FVTX Proposal Update

Matching MuTr and Silicon tracks in Central AuAu

Matching MuTr and Silicon tracks in Central AuAu

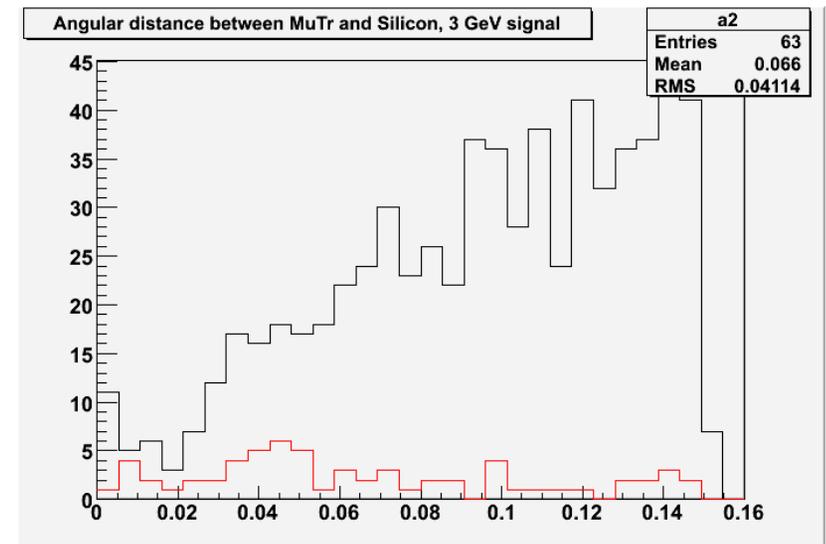
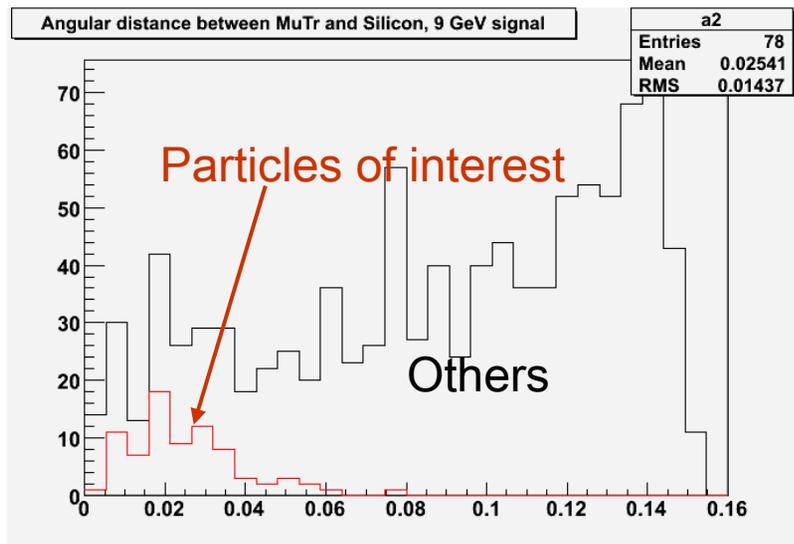
1. It must be verified that muon tracks can be connected to tracks in the FVTX in Au+Au collisions.

Issue: in Central AuAu events, approximately 3 silicon tracks are found that approximately match each MuTr track

- Mix Central AuAu events with single muons
- For mixed track:
 - Find MuTr track which has most MC contributor hits (reconstructed track)
 - Find all silicon stubs that are within a 2-d angular window of this track
 - Fit each set of potential silicon hits with the MuTr track and store fit results
 - Look at distributions for tracks that are properly matched and those that are not
 - Attempt to select best match, just using χ^2

FVTX Contributions—Reduction of Decay Background

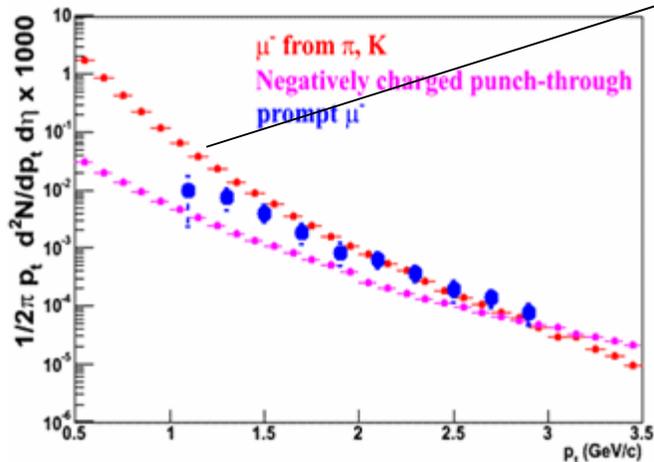
4. The separation of b and c decays based on decay length with reasonable RHIC II luminosity should be shown

- Cutting on $DCA < DCA_{max}$ allows long-lived π, K decays to be separated from heavy quark decays AND cleaner sample of π, K at forward rapidity
- Especially necessary to access low p_T spectra

J/ ψ , ψ' Measurement Improvement with FVTX

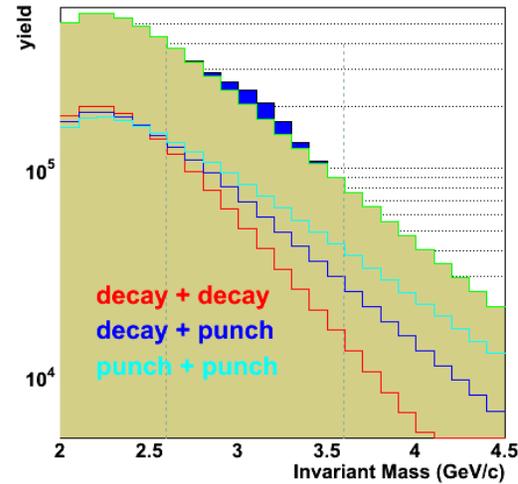
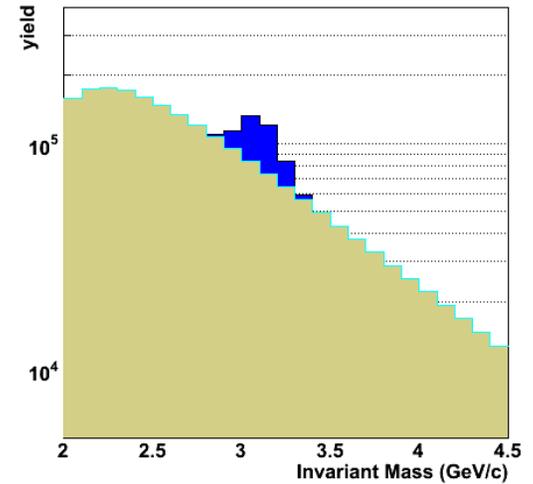
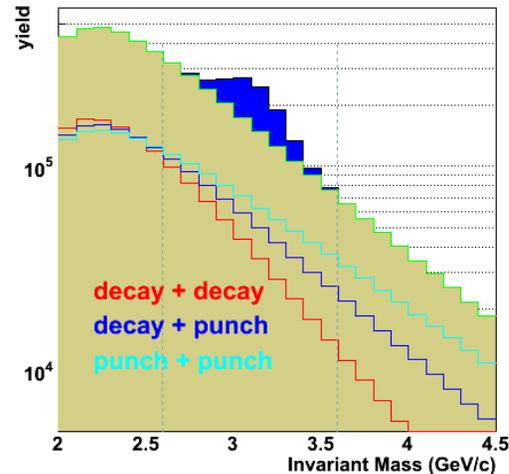
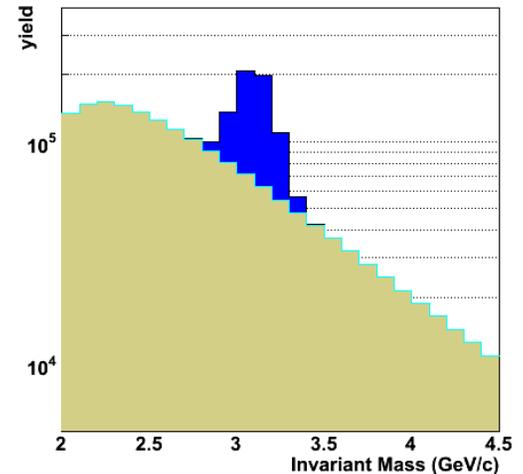
3. The statistical significance of the ψ' in Au+Au collisions with a reasonable RHIC II luminosity should be shown.

without and with FVTX :

- mass resolution improvement
- background rejection
